Stage 1/2 Road Safety Audit

**Strategic Housing Development, Dunlo, Ballinasloe,
Co Galway**

On behalf of Limekill Esker Ltd

August 2022

3.2.5 Disabled User Parking Bays

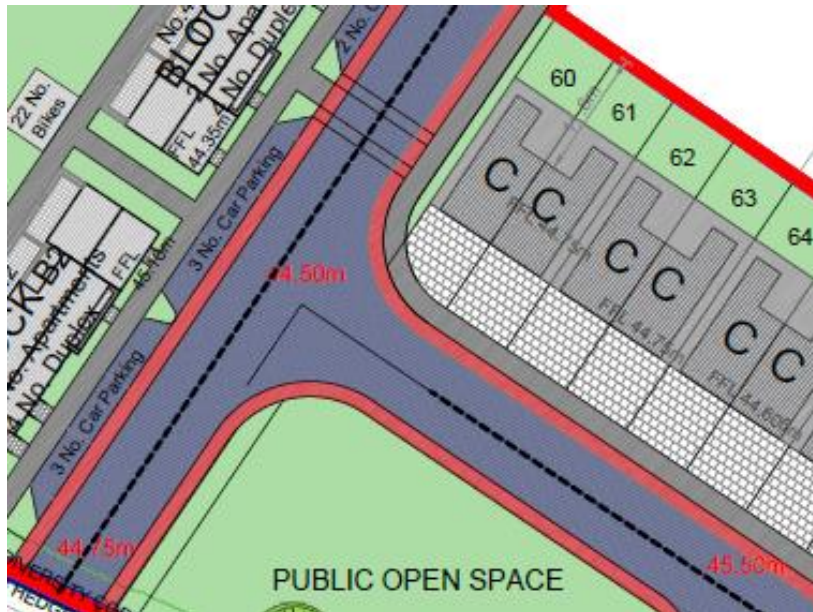
Problem: The disabled user parking bays extend into the “live” carriageway.

Hazard: Users of the bays who are attempting to access/egress the rear of their vehicles may be struck by passing traffic.

3.2.4	Yes	Yes	Buffer strip to be provided within parking bay	
3.2.5	Yes	No	These bays are not located on roads subject to through traffic. Where the bays are not at the end of cul-de-sacs with no parking directly opposite, they will be relocated to be such, or altered so that the the rear of the disabled user bay does not extend further into the carriageway than the adjacent parking bay.	Yes

3.2.7 Cycle Lane at Junctions

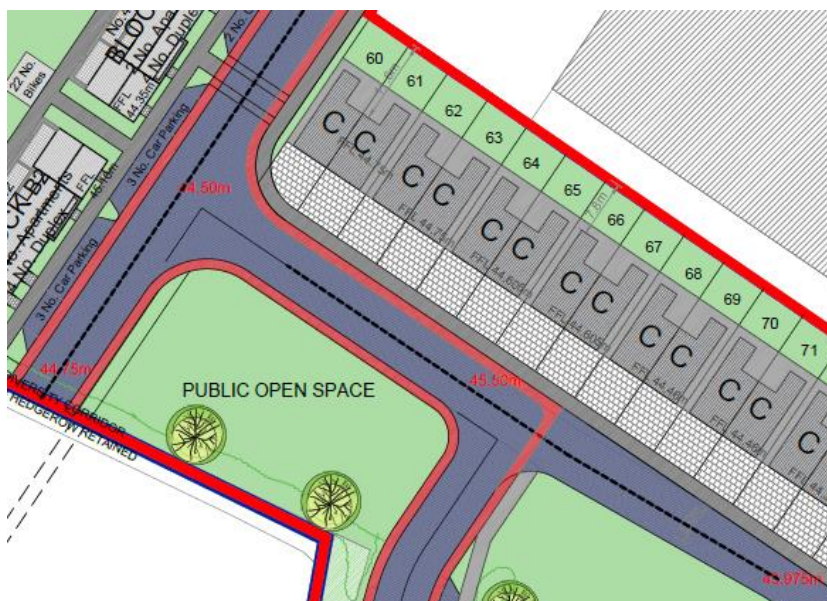
Problem: The design of the cycle lane does not make allowance for cyclists to turn right out of the minor arm in safety.

Hazard: The cyclist may be struck by motorists.

Recommendation: Redesign the cycle lane and implement the recommendations shown in the national cycle manual

3.2.6	Yes	Yes	These will be revised at Design Stage	
3.2.7	Yes	Yes		
3.2.8	Yes	Yes		
3.2.9	Yes	Yes		
3.3.1	Yes	Yes		
3.3.2	Yes	No	Bin storage area to be relocated closer to junction to avoid need for refuse truck entry	Yes
